SERVICE LETTER SL21 66-47200 Rev A

Part/Assembly #: 66-47200

Float Model Affected: Aerocet Model 6650 floats

Affected: Hydraulic Pump Motor

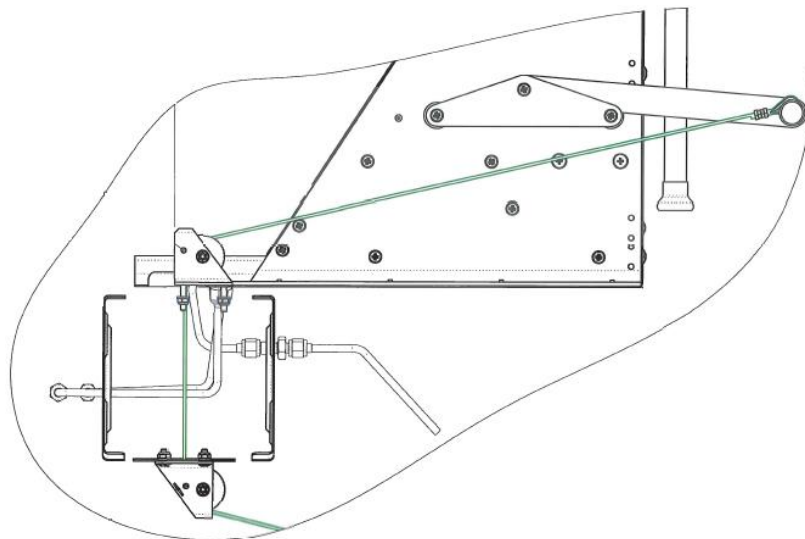
Reason for Change: Premature gear wear

Corrective Action: Remove and replace hydraulic pump motor.
